Jay Jay Mills(Bangladesh). Pvt. Ltd.

1st July 2014

Observations

Typical Floor plan

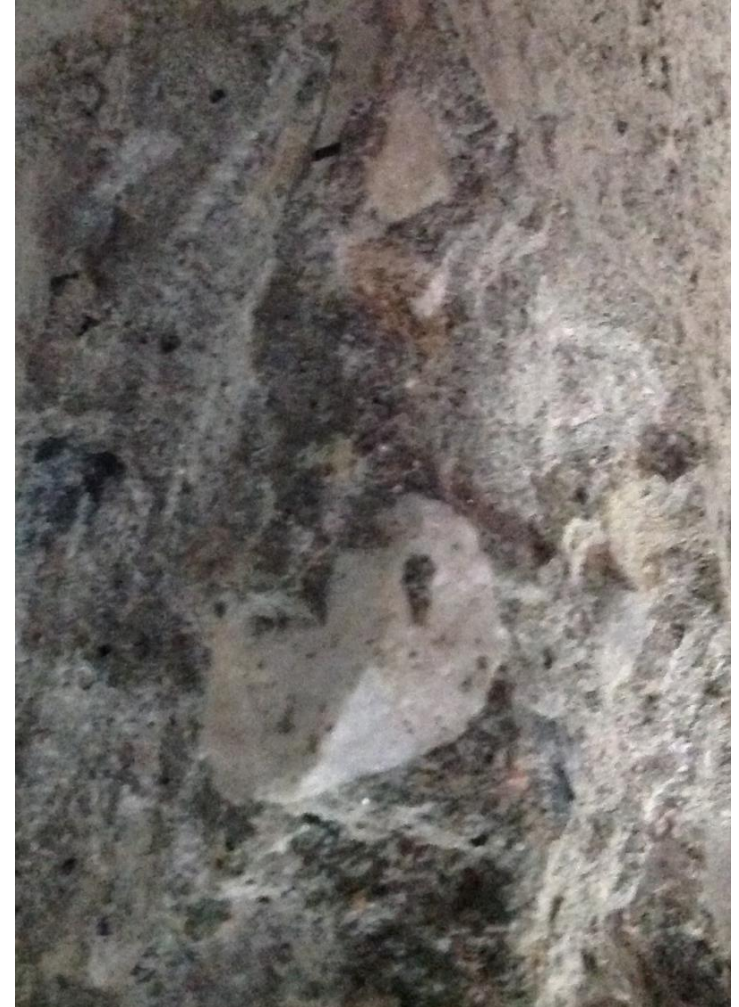
Columns, which support toilet area floor build-up loads, appear to be stressed in excess of normal design limits

Highly stressed column locations – in the area of toilets

Item No.	Observation	Recommended Action Plan	Recommended Timeline
1	Columns, which support toilet area floor build-up loads, appear to be stressed (at ground floor level) in excess of normal design limits.	Factory Engineer to review design, loads and column stresses in area identified above.	6-weeks
2	Columns, which support toilet area floor build-up loads, appear to be stressed (at ground floor level) in excess of normal design limits.	Verify insitu concrete strengths (using min. 4 no. 100mm dia. Cores) and existing reinforcement for all columns in the highlighted area.	6-weeks
3	Columns, which support toilet area floor build-up loads, appear to be stressed (at ground floor level) in excess of normal design limits.	Produce and actively manage a loading plan for all floor plates within the factory giving consideration to floor capacity and column capacity.	6-weeks
4	Columns, which support toilet area floor build-up loads, appear to be stressed (at ground floor level) in excess of normal design limits.	Continue to implement load plan (See Item 2)	6-months

Column Strength

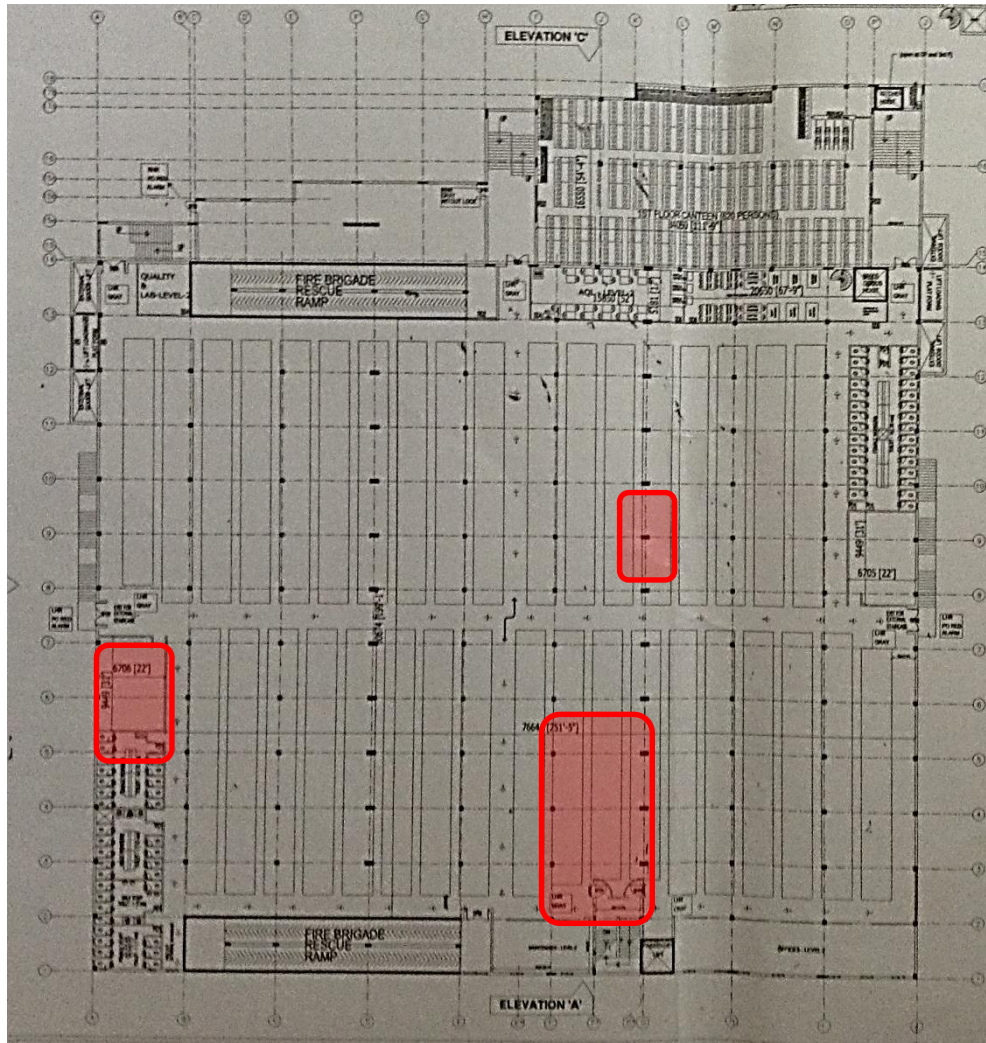
Stone aggregate observed in columns

Typical floor plan

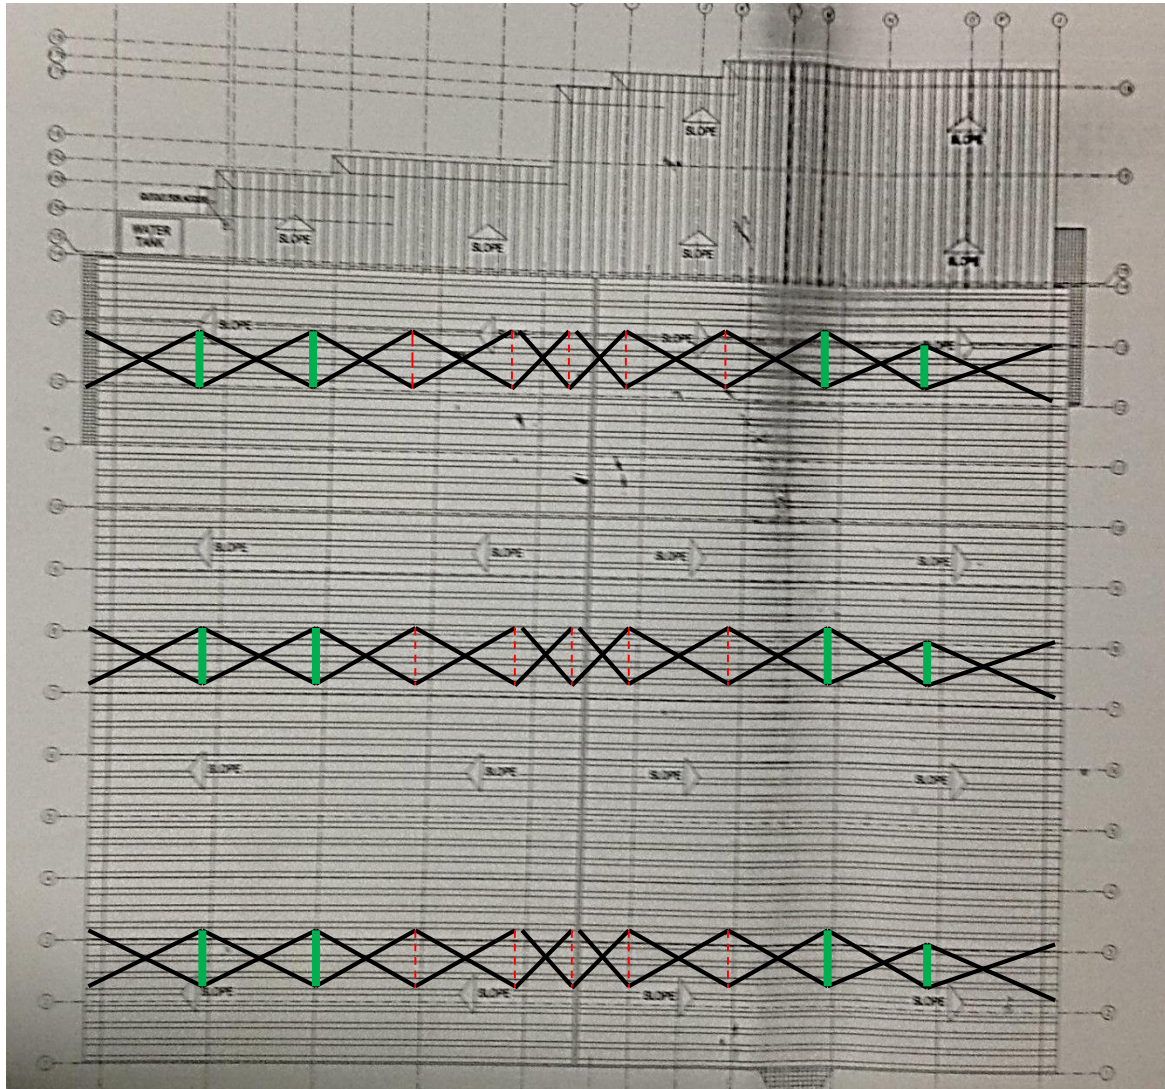
Management of floor loads

Unmanaged storage

Area of material storage on 1st floor

Item No.	Observation	Recommended Action Plan	Recommended Timeline
5	Management of floor loads	Produce and actively manage a loading plan for all floor plates within the factory giving consideration to floor capacity and column capacity. (Refer to Item 1)	6-weeks
6	Management of floor loads	Implement floor loading plans on an on-going basis.	6-months
7	Compression struts missing from roof bracing system	Building Engineer to assess roof bracing system for lateral wind loading as per BNBC. Particular consideration should be given to missing compression struts in braced bays	6-months
8	Compression struts missing from roof bracing system	Building Engineer to design and detail structural upgrading works, as necessary.	6-months
9	Roof Support Baseplate anchored both sides of Movement joint	Building Engineer to monitor baseplate connections across movement joints given consideration to spalling of concrete around anchors.	6-months

Production Building - Roof Plan

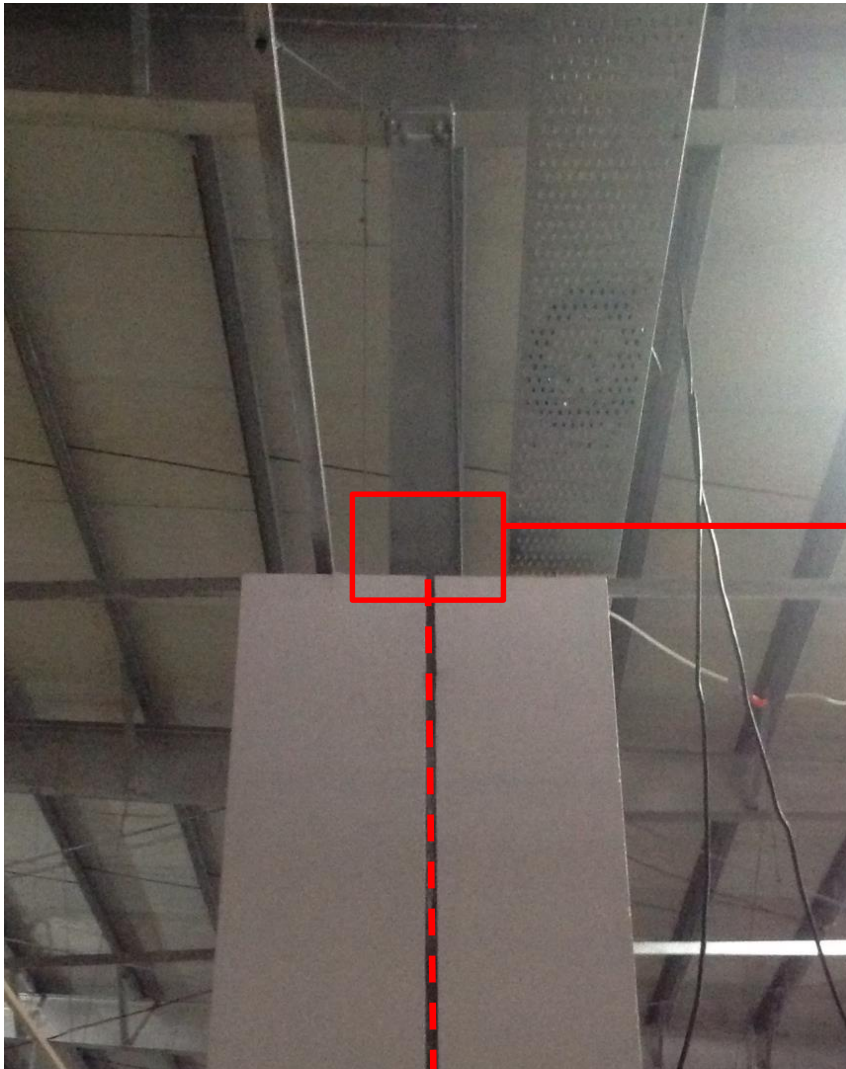
Missing Compression Struts to Roof Bracing System

Missing Compression Struts to Roof Bracing System

- Missing Compression Strut
- Existing Tension only member
- Existing Compression Strut
